Halley Estates II - Lot 14

Re: Lot 14
Tax Lot: 25.09-1-2.3
34 Cornell Peak
Halley Estates II

The following is our response to Martin K. Spence, PE, Village Engineer, of Spence Engineering letter dated March 15, 2022:

Re: Halley Estates II – Lot 14

HALLEY ESTATES-II
 VILLAGE OF PONONA
 ROCKLAND COUNTY, NEW YORK
STEEP SLOPE PLAN & CUT & FILL PLAN
LOT NO. 14

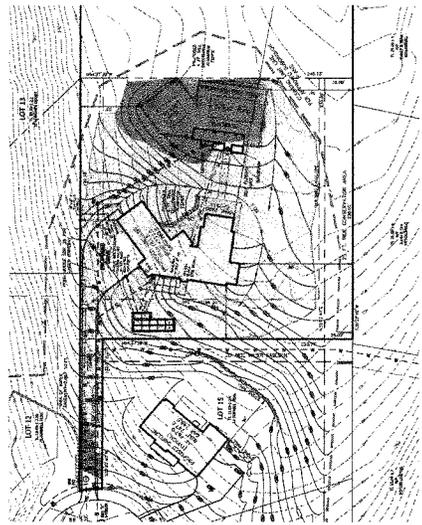
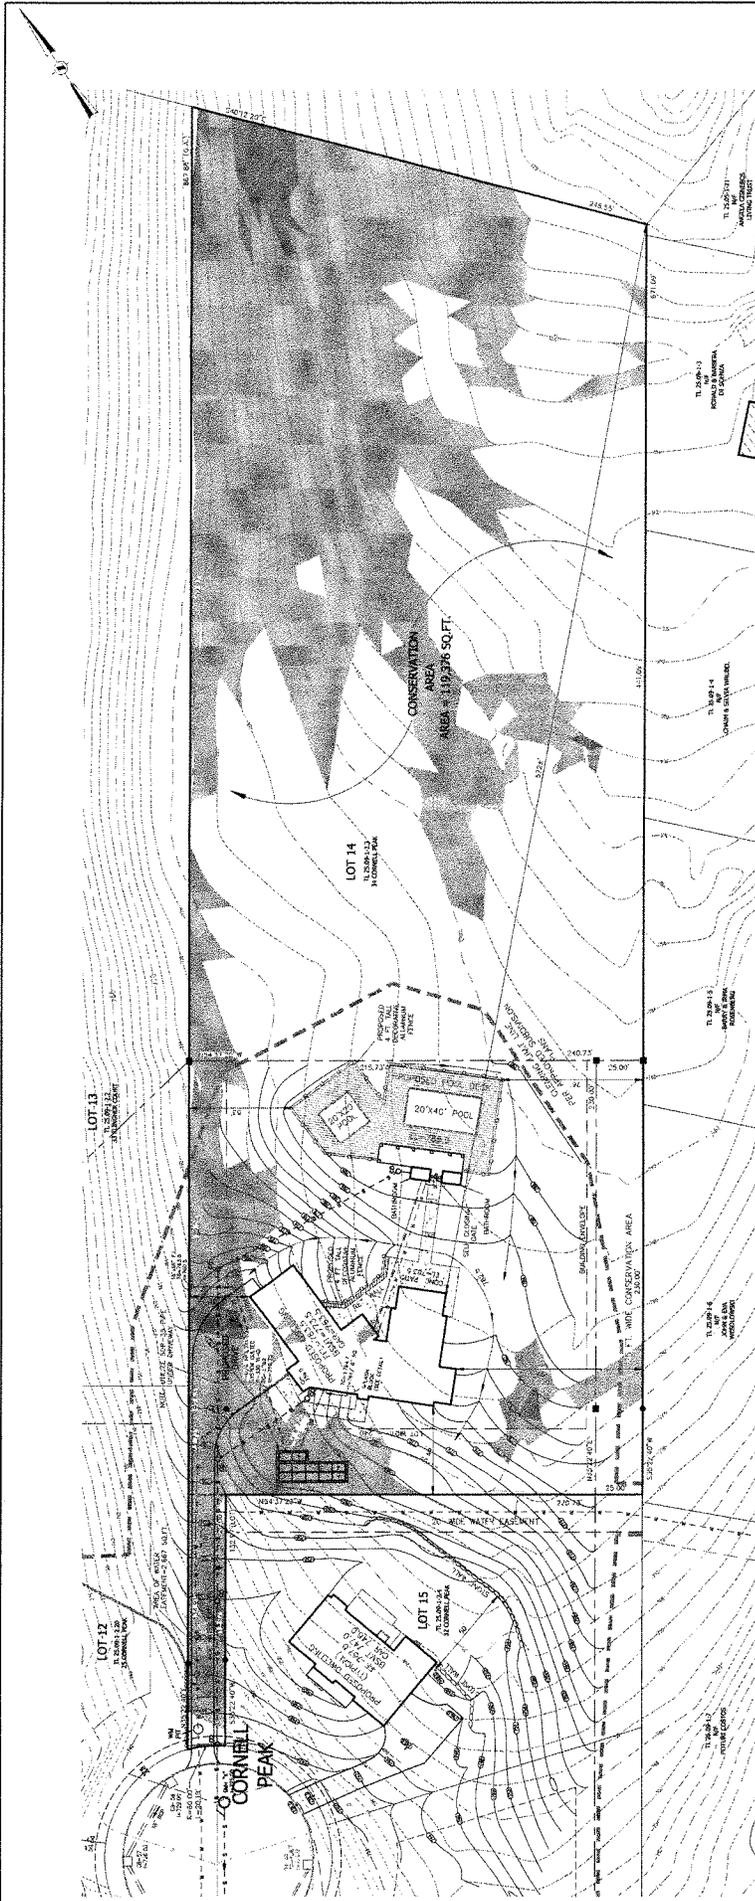
4. The development of a single-family home requires site plan review under the steep slope provision of Chapter 119 of the Village Code. A steep slope calculation within the disturbed area is provided on sheet 4. The proposed steep slope area to be disturbed has a weighted area of 18,056 square feet. The threshold for Planning Board review is 13,068 square feet of weighted area.
